City of Arvada

Design Review Advisory Committee

Arvada Garage – New Canopy
7611 Grandview Avenue
DA2023-009

ARVADA GARAGE
DA2023-0009
Guidelines Matrix

1 PROPOSED SITE PLAN
1/8" = 1'-0"

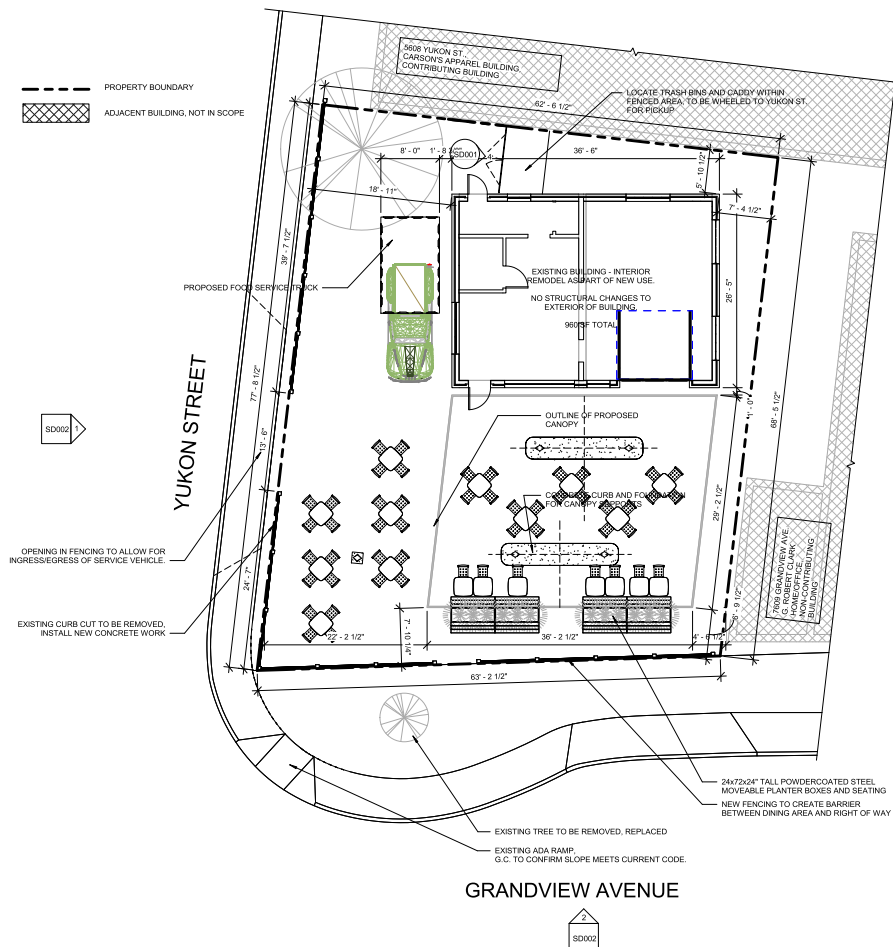
A partial waiver is required to allow the outdoor dining area at the scale that is being proposed. The existing building is very small (960 sq. ft.), covering only 21 percent of the site and is set back more than 30 feet from Grandview Avenue. The outdoor dining area will all be placed in front of the building (some of it covered by the canopy) and could appear more than subordinate to the building given the existing condition of the site.

A partial waiver is required in order to allow the service area to be placed adjacent to another use. The use to the north is another commercial use and is the best practical spot for the service area to be located. This locating is best for screening purposes and to be able to locate it as far away from the street and sidewalk as possible.

The applicant intends to keep the existing surface lot, however, parking will be removed and an outdoor patio area built. The adjacent sidewalk will be improved and brought up to current City standards.

Staff supports this partial waiver based on criteria 1 of section 8-3-5-4 of the LDC.

Staff supports this partial waiver based on criteria 1 and 2 of section 8-3-5-4 of the LDC.

① WEST ELEVATION
1/4" = 1'-0"

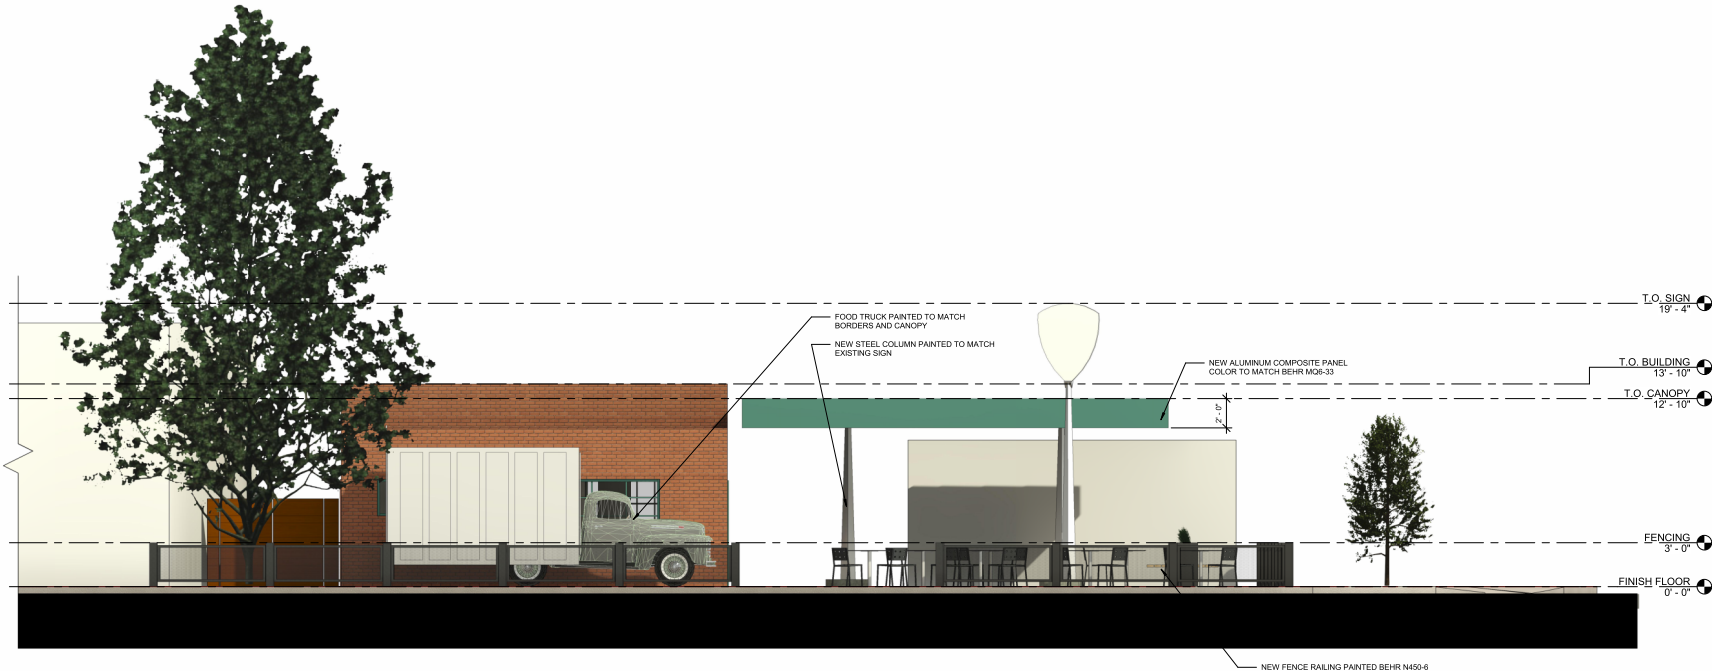
A partial waiver is required to allow the construction of a post supported canopy. The canopy will be detached from the building in order to prevent any alterations to the façade and will be one foot shorter than the building in height. The canopy will feature a total of four steel columns to support it. And will feature a two-foot-wide aluminum composite panel. The canopy will be located between the building and Grandview Avenue. The panel will be painted the same color as the doors and window frames. The canopy will not be internally illuminated.

A partial waiver is required to allow this more modern design style for the canopy. The modern design reflects the time in which it is being built without negatively impacting or altering the existing building or its storefront construction.

A partial waiver is required to allow the canopy to be constructed of aluminum composite. The canopy is being built to reflect the era in which it is being built. The canopy is a structure that will be detached from the primary building and could be removed at some point in the future without harming the primary building. The material will also closely match the material (metal) used on the existing pole sign that will remain.

Staff supports this partial waiver based on criteria 1 of section 8-3-5-4 of the LDC.

Staff supports this partial waiver based on criteria 1 and 4 of section 8-3-5-4 of the LDC.

Staff supports this partial waiver based on criteria 1 of section 8-3-5-4 of the LDC.
